**RE: 33-35 TREACY STREET, HURSTVILLE  
PARKING STATEMENT**

As requested, please find herein The Transport Planning Partnership (TPPP) parking statement for the above development site to support the modification of parking provision in compliance with Apartment Design Guide (ADG) instead of the Georges River Council (Council) DCP that was previously adopted in the Traffic and Parking Assessment.

project 33-35 TREACY STREET WEST STAGE  
(WEST STAGE) HURSTVILLE

drawing no DA 06

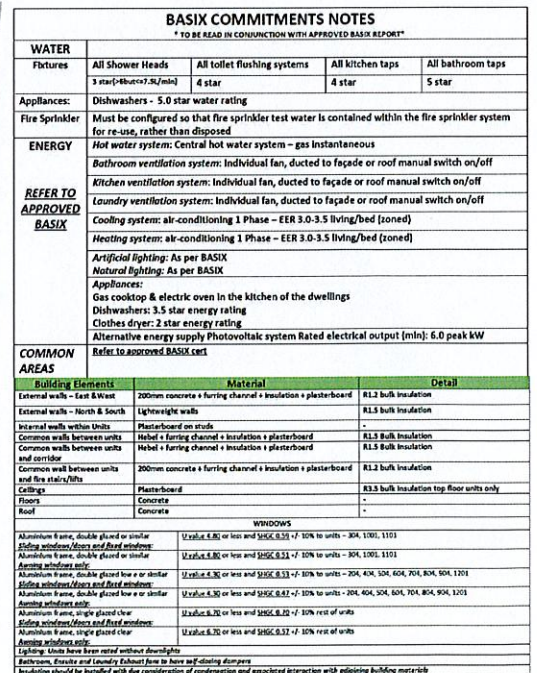
Additionally, the basement car park is proposed to be reduced from four levels to three levels, resulting in a reduction from 75 to 58 spaces as shown in Attachment One.

LEVEL	TOTAL NUMBER OF CAR SPACES
B2A+B	25
B1A+B	25
B1C	8

TOTAL: 58

**1 LEVEL 1 (GROUND)**  
1 : 200 @ A1(1:400 @ A3)

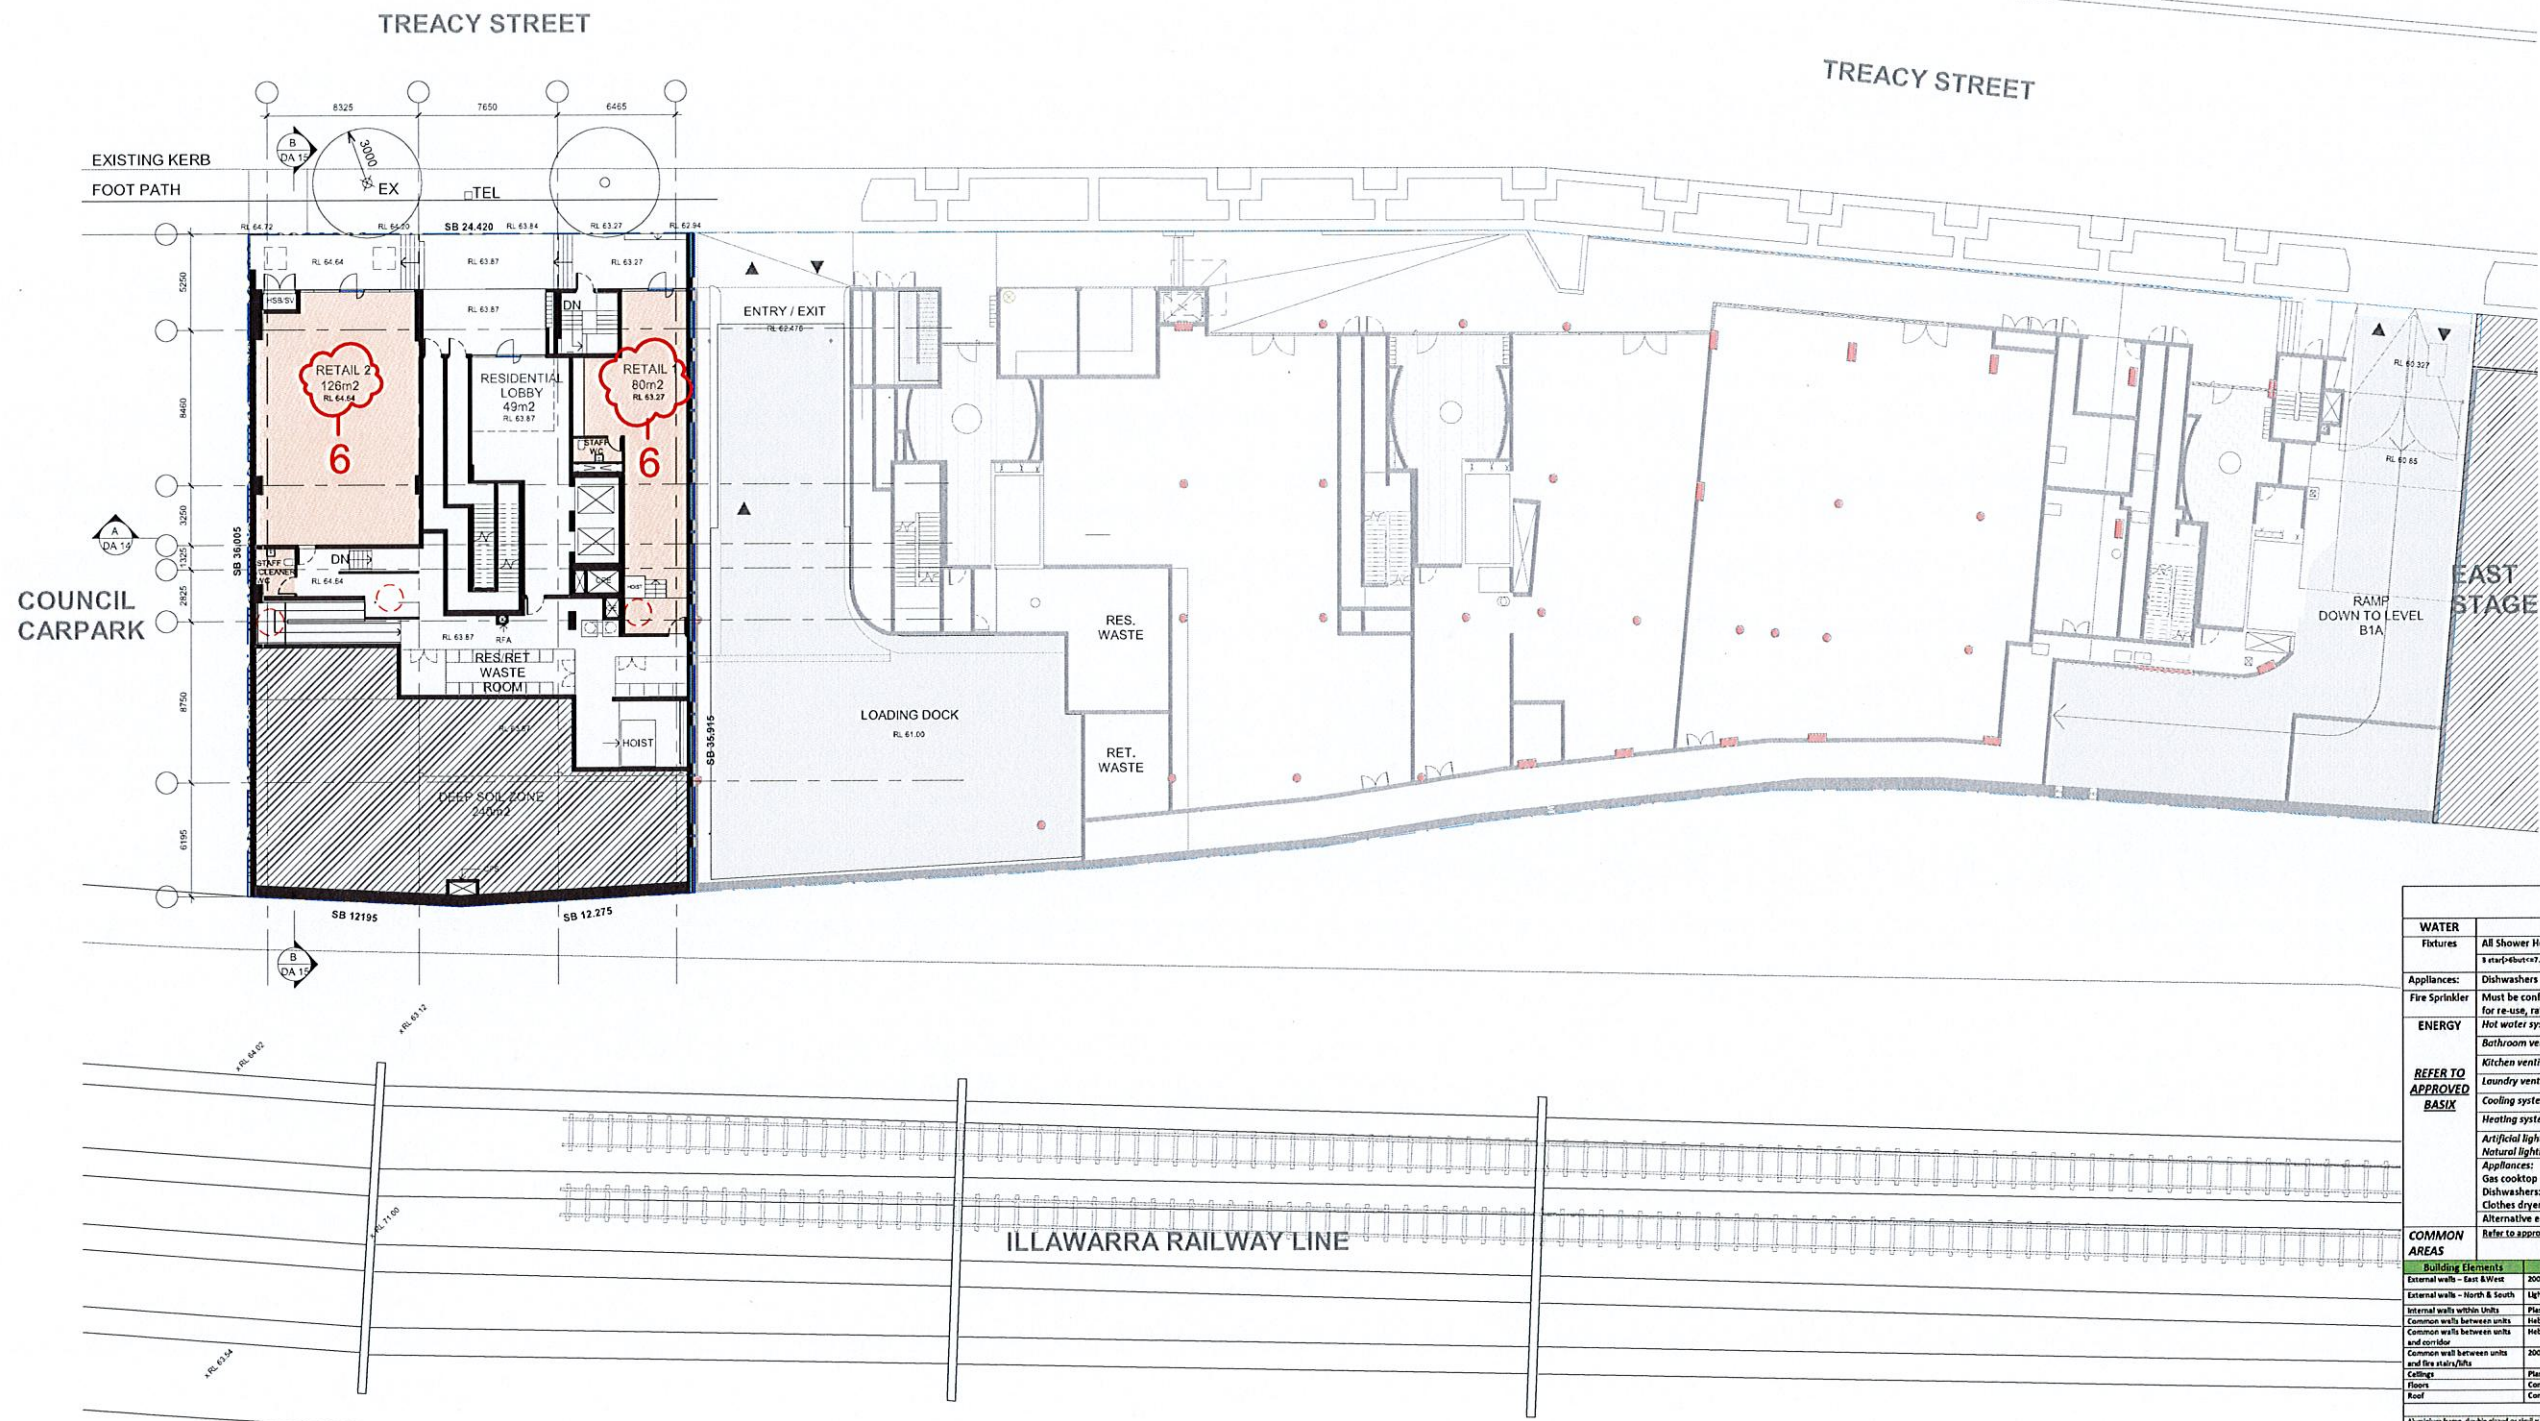
- MODIFICATIONS:**
- 1. WINTERGARDENS INCLUDED IN GFA
  - 2. GFA SCHEDULE AMENDED
  - 3. SNORKEL WINDOWS TO SECONDARY BEDROOMS EXTENDED 1 METRE
  - 4. BASEMENT B3 DELETED
  - 5. BASEMENT RESIDENTIAL STORAGE RELOCATED
  - 6. RETAIL AREA AMENDED TO MATCH RETAIL GFA

issue	amendment	date	legend
A	AMENDMENTS IN RESPONSE TO COUNCIL COMMENTS	10/07/20
